Attachment 2 to AEP:NRC:1018

Proposed Revised Technical Specification Pages

AttachmentD.C. COOK UNIT 1 TECHNICAL SPECIFICATION CHANGE

DC Cook Unit 1 - Peak Pellet Burnup Extension

FIGURE 3.2-4
 Exposure Dependent F_Q Limit, $F_Q^L(E)$, and Normalized Limit $T(E)$ as a function of Peak Pellet Burnup for Exxon Nuclear Company Fuel

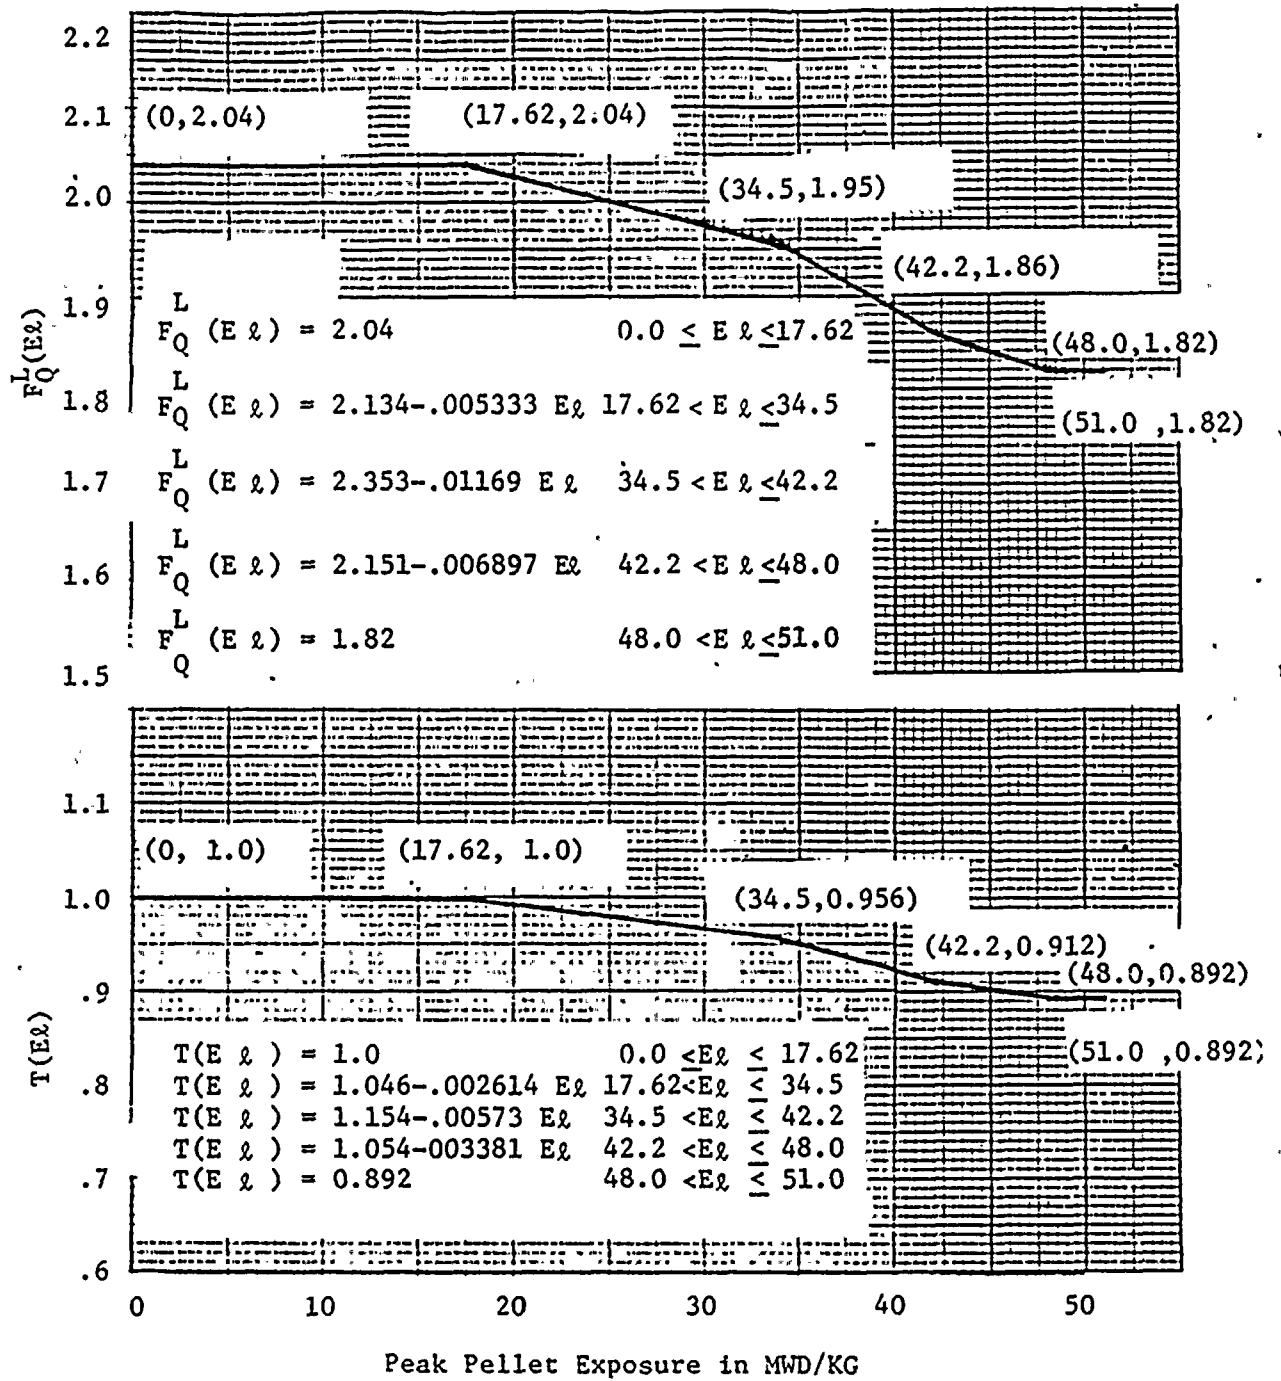
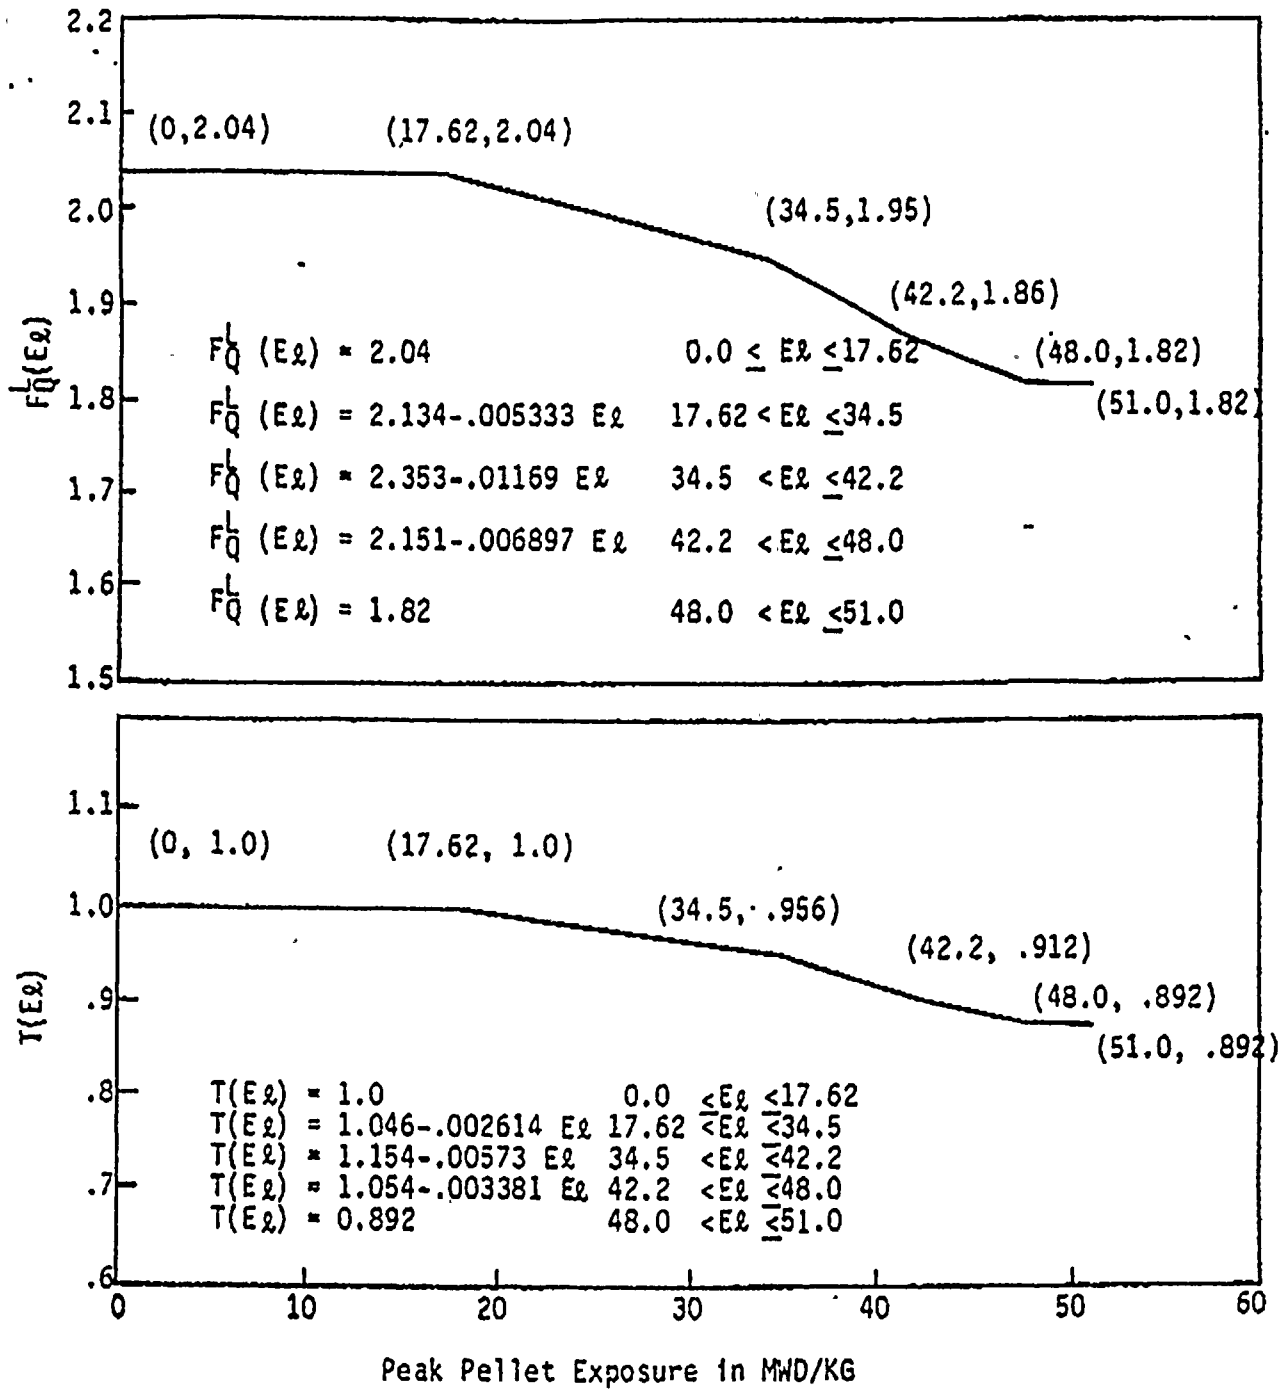
The recommended D.C. Cook Unit 1 exposure dependent F_0 Technical Specification Figure 3.2-4 is attached. This figure is the same as the figure in the current D.C. Cook Unit 1 Technical Specification but with the addition of a constant F_0 limit of 1.82 from 48.0 Gwd/MT to 51 Gwd/MT peak pellet exposure. For consistency with the current D.C. Cook Unit 1 Technical Specification, the curve has been maintained in terms of peak pellet burnup.

Figure 1 Hot Channel Factor Normalized Operating Envelope, $F_Q=2.04$, $K(Z)$ Function

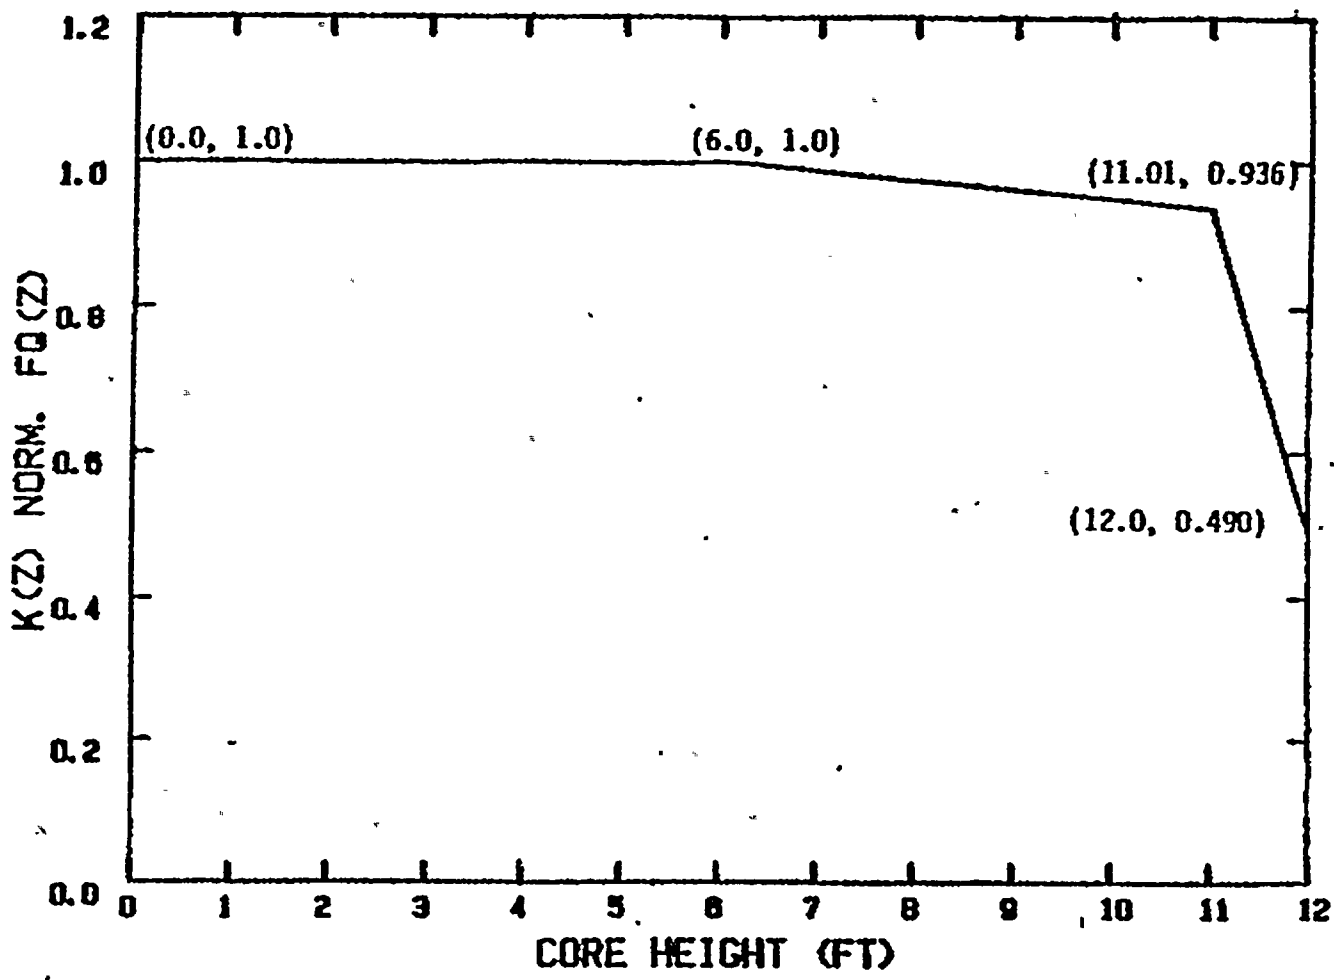
A LOCA/ECCS analysis justifying the operation of ENC fuel currently in the D.C. Cook Unit 1 reactor is presented in Reference 1. The analysis in that report supports a peak F_0 of 2.04 with an axial dependence as shown in Figure 1. This analysis is applicable to the ENC fuel currently in the D.C. Cook Unit 1 reactor, with a minimum peak rod average exposure greater than 20 Gwd/MT and anticipated to be less than 47 Gwd/MT.
